ADDENDUM NUMBER: TWO (02)

ADDENDUM DATE: November 5, 2018

PROJECT: New Employee Housing and New Garage
Black Lake and Stony Rapids, Saskatchewan

S-2-1 REF. DRAWING S1 – HOUSING UNIT PLANS AND DETAILS

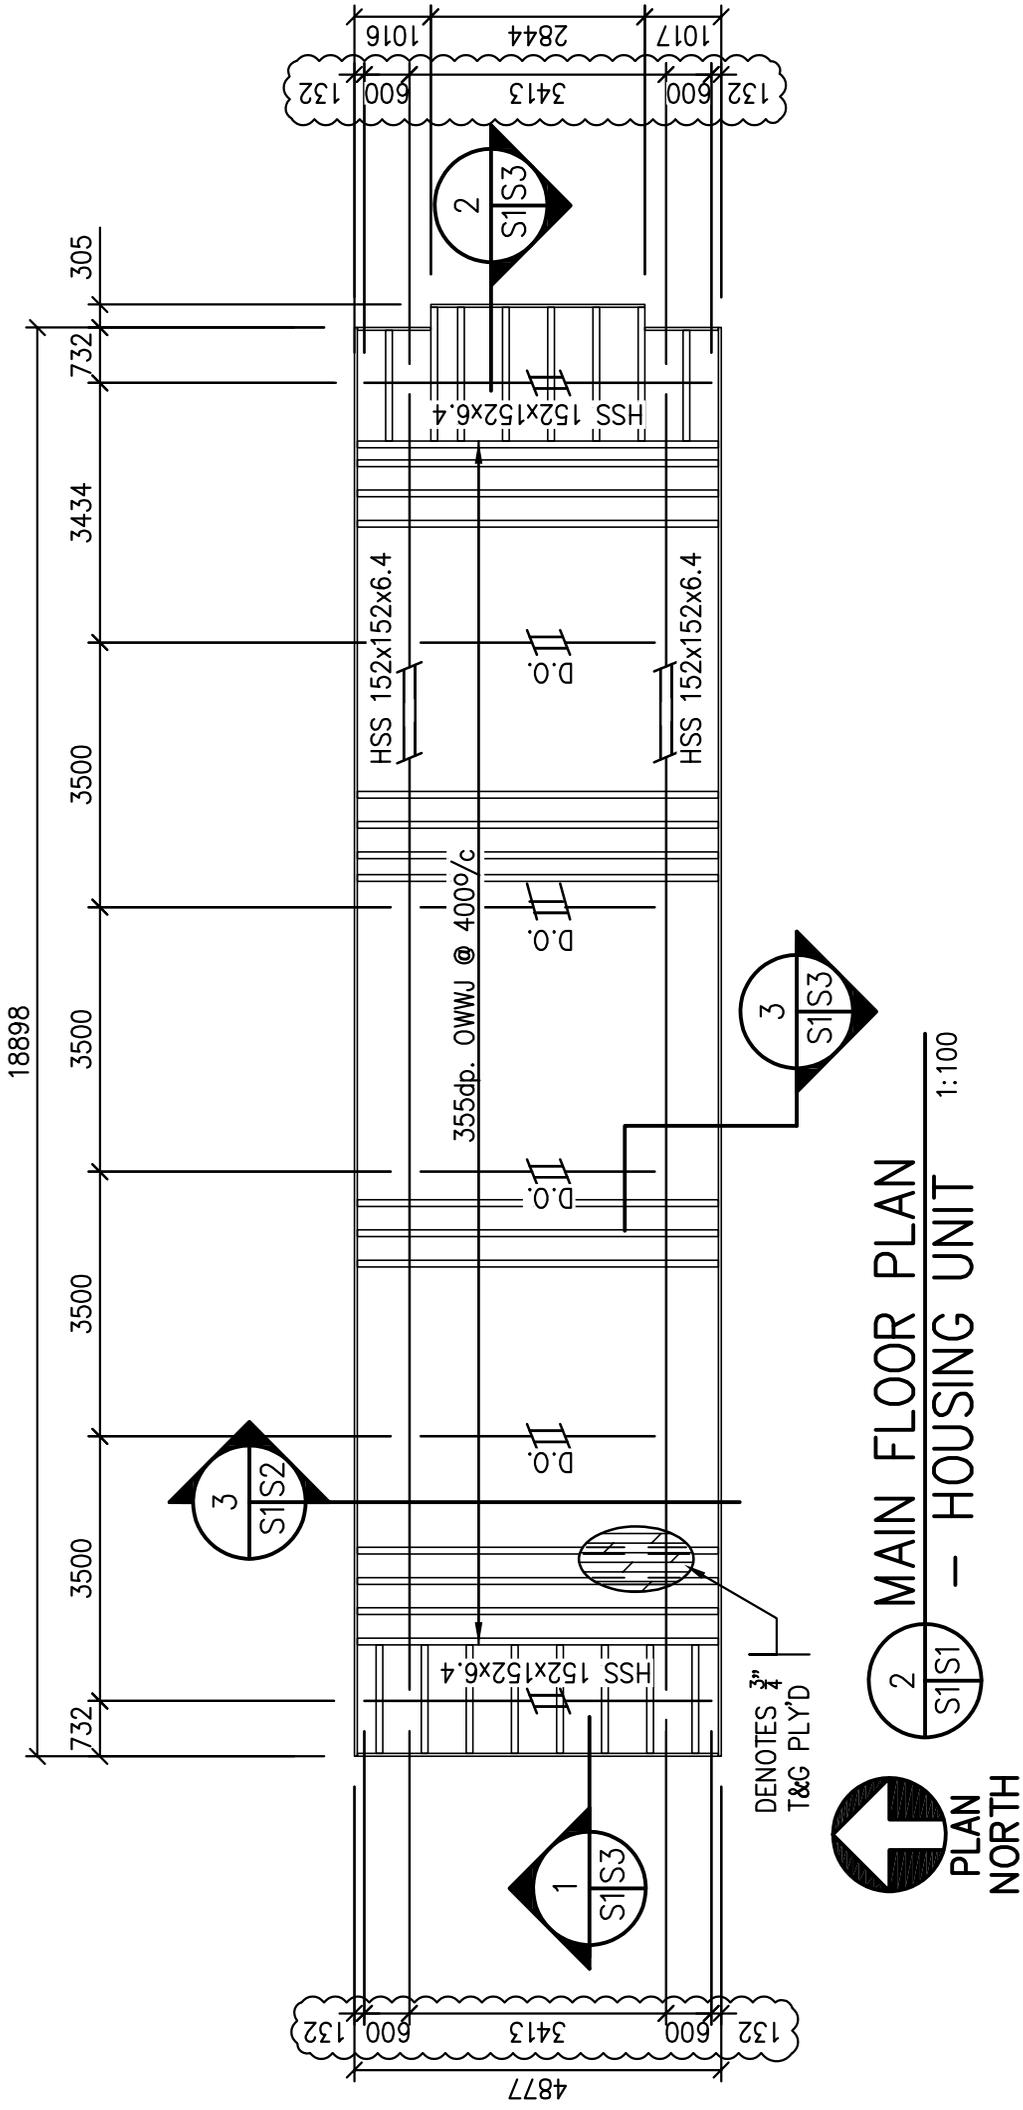
- .1 **Q:** Our engineer has found on drawings S1 #3 that there are some joist that have no support. Can we get clarification from the consultant on how they would like to support these floor joists.
A: See below S-2-1 for clarification.

1. **Replace:** Drawing 2/S1 Main Floor Plan – Housing Unit with attached sketch SK1.
